# CITY OF ALBUQUERQUE

**RE: 1001 Adobe Rd. NW**  
**Grading and Drainage Plan**  
**Engineer's Stamp Date: 10/07/22**  
**Engineer's Certification Date: 01/31/23**  
**Hydrology File: F14D081**

# GRADING AND DRAINAGE PLAN

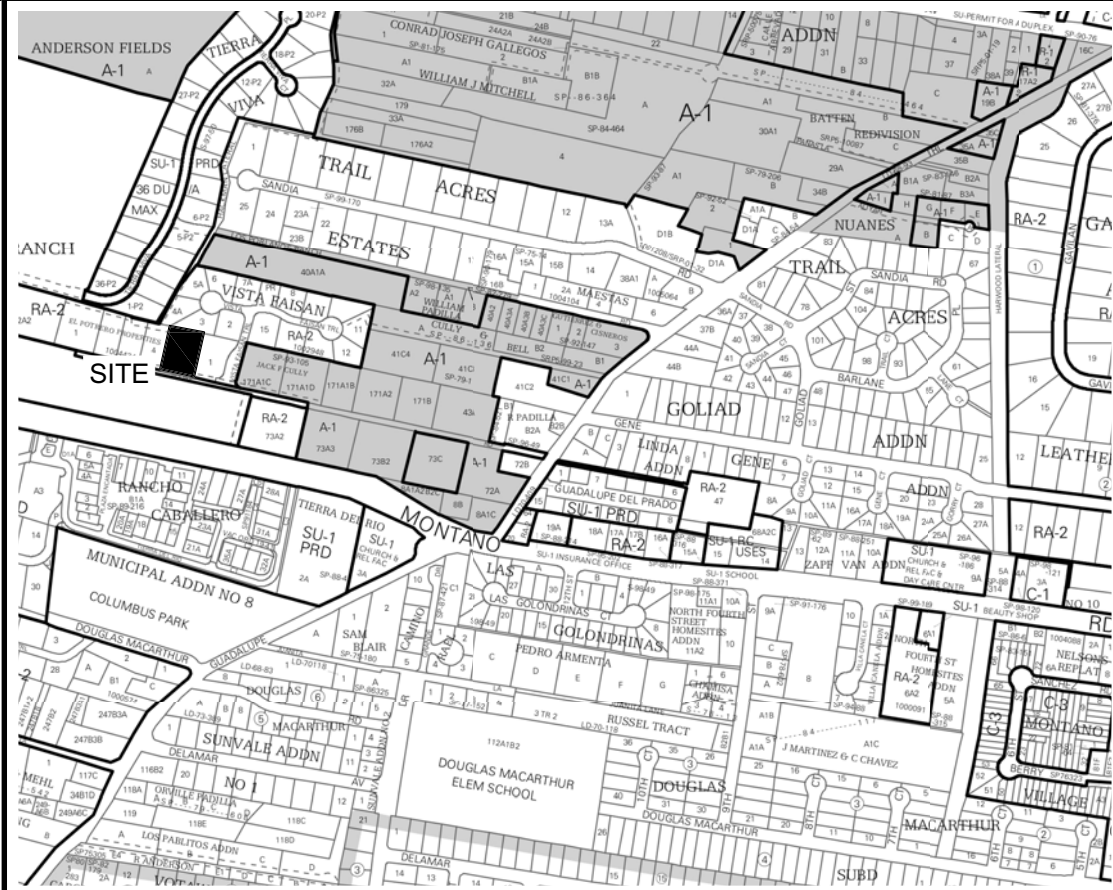
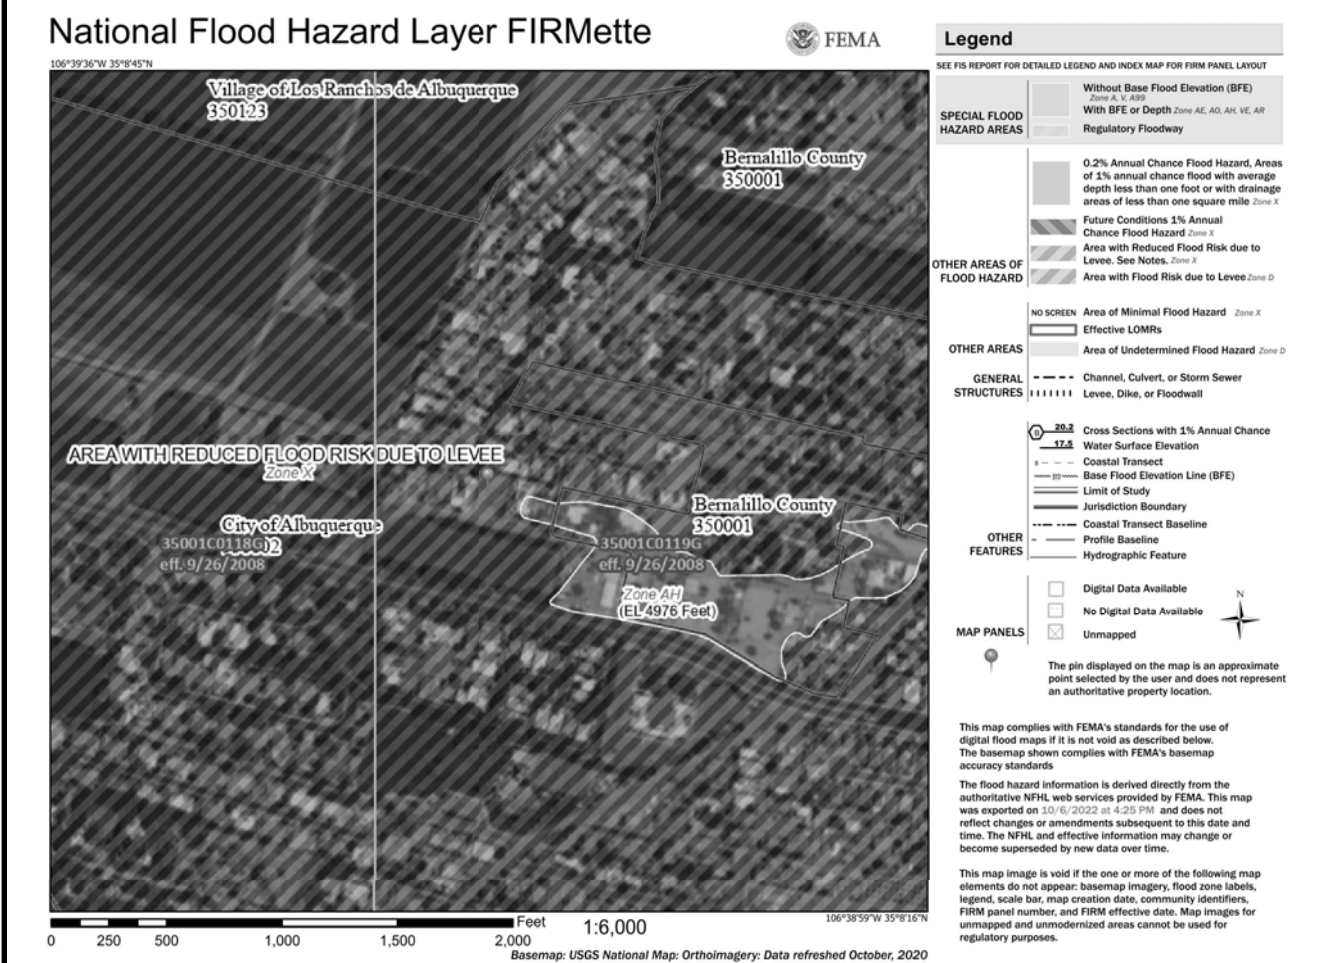
Based upon the information provided in your submittal received 02/02/2023, the Grading and Drainage Plan is approved for Building Permit and Building Pad Certification for 1001 Adobe Rd. NW. Please attach a copy of this approved plan in the construction sets for Building Permit processing along with a copy of this letter.

1. Engineer's Certification, per the DPM Part 6-14 (G): Engineer's Certification Checklist for Subdivision and Part 6-14 (H): Required Certification Language is required.
